Work Order ID 149076

Item Name: Fwd, Center Ceiling Panel Assembly

DRAWING NO. **D4634** REV. G
SHEET 1 OF 17

TITLE **CENTER CEILING PANELS** SCALE NTS

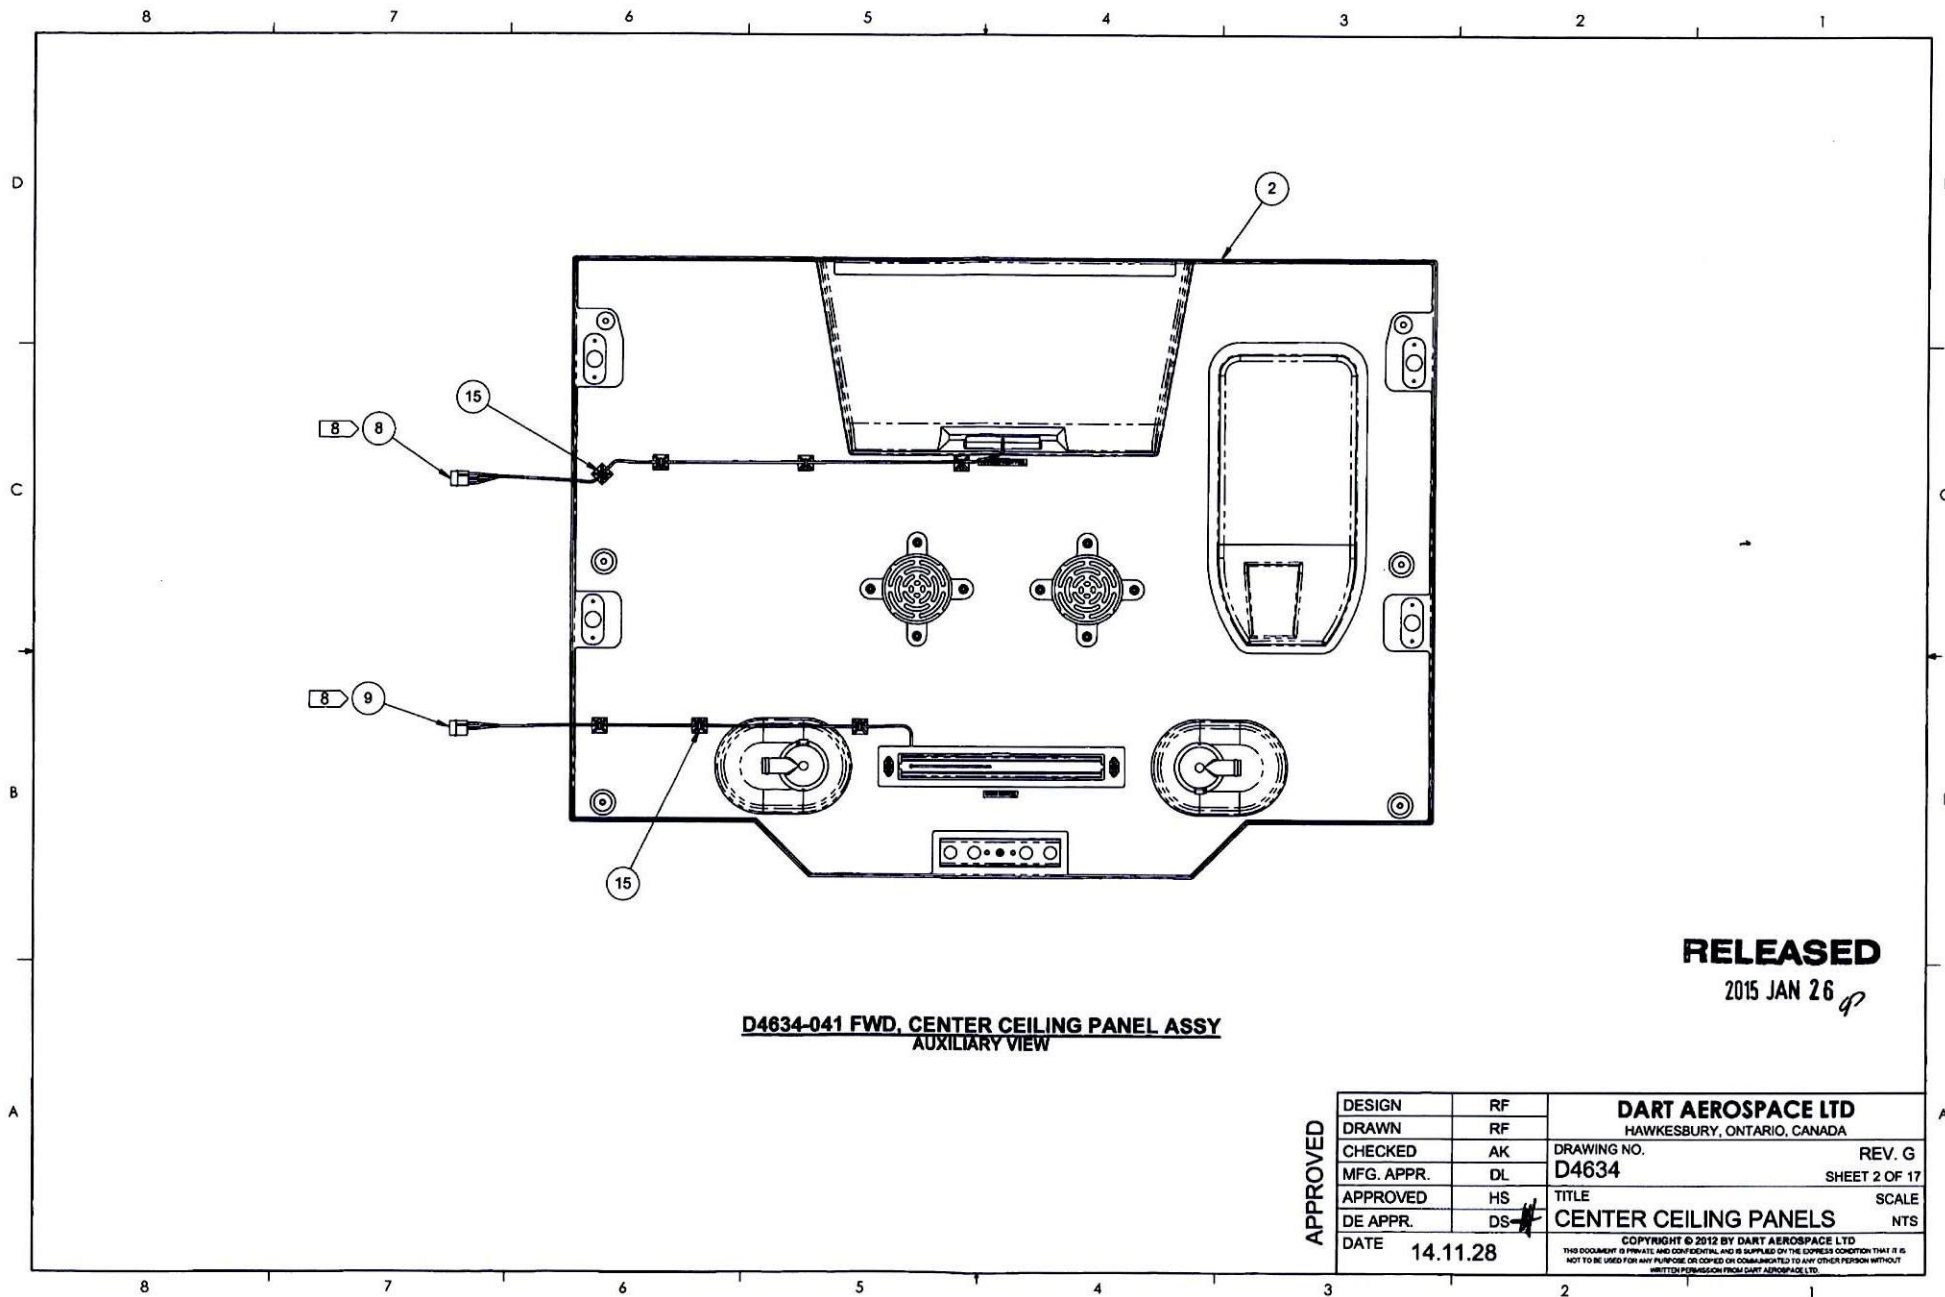
G	D4652-5 WAS D4652-1 (ZN D4-1, D4-3, D4-5); 10.28 WAS 10.20 (ZN B8-10, B5-12, B5-14); TIE-WRAP & MOUNTING PAD QTY CHANGE; MOUNTING PAD EDGE DISTANCE CHANGE	RF	14.11.28
F	REVISE BOM (ZN D4-7); ADD DIM (ZN B8-9); 10.20 WAS 10.05 (ZN B8-10, B5-12, B5-14); ADD DETAIL V (ZN C4-10, B4-12, C4-14, A4-16); CHANGE PROTRUDE SECTION DIMS TO REF (ZN C7-10, C7-12, C7-14)	RF	14.02.03
E	REVISED BOM (ZN C4-1, C4-3, D4-5, C4-7, C4-8, C4-9); ADDED NOTE 11) (ZN D5-7, A8-7, D5-8, A8-8, D7-9, A8-9); 3.70 WAS 3.83 (ZN C6-11); 1.88 WAS 2.00 (ZN D7-13); 6.13 WAS 6.25 (ZN B6-15); REVISE DETAIL B (ZN A8-16)	RF	14.01.09
D	ADDED PLT1.5M-M (ZN C4-5, C6-6); D5021-1 (ZN D4-7, D5-7); D5021-3 (ZN D4-8, D5-8); D5021-5 (ZN D4-9, B7-9); MPNY-750S-9-C (ZN D4-9, B7-9); Ø 0.129 (ZN B4-11, B4-13); DETAIL "U" (ZN C2-17); 3.83 WAS 3.87 (ZN C6-11); 2.00 WAS 2.02 (ZN D6-13); REVISE NOTE 8) & 10) (ZN A8-7, A8-8, A8-9); & NOTE 1) (ZN A8-10, A8-12, A8-14); 3.80 WAS 3.84 (ZN D4-17, B8-17); REMOVED D4694-7/-041/-043/-045/-047; D4647-3/-7/-8; DIMENSION SHIFTED DUE ADDING D5021-1/-3/-5; Ø 0.250 WAS Ø 0.208 (ZN D6-11, C3-13 & D6-15)	RF	13.12.09

C	REVISE GENERAL NOTES (ZN A8-7, A8-8, A8-9) & BOM (ZN D4-1, D4-3, D4-5, D4-7, D4-8); Ø 0.208 WAS Ø 0.207 (ZN D6-11, C3-13, C6-15) ADD DIM. (ZN B6-7, B7-7, D7-8, & D6-8)	RF	13.06.18
B	ADDED D4634-141/-143/-145 (ZN B4-7, B4-8, B4-9); REVISE D4634-041/-042/-043/-044 PART LIST & GENERAL NOTES; ADD DETAILS R,S,T SHT 10, 12, 14, 16, 17	RF	12.11.30
A	NEW ISSUE	RF	12.07.25
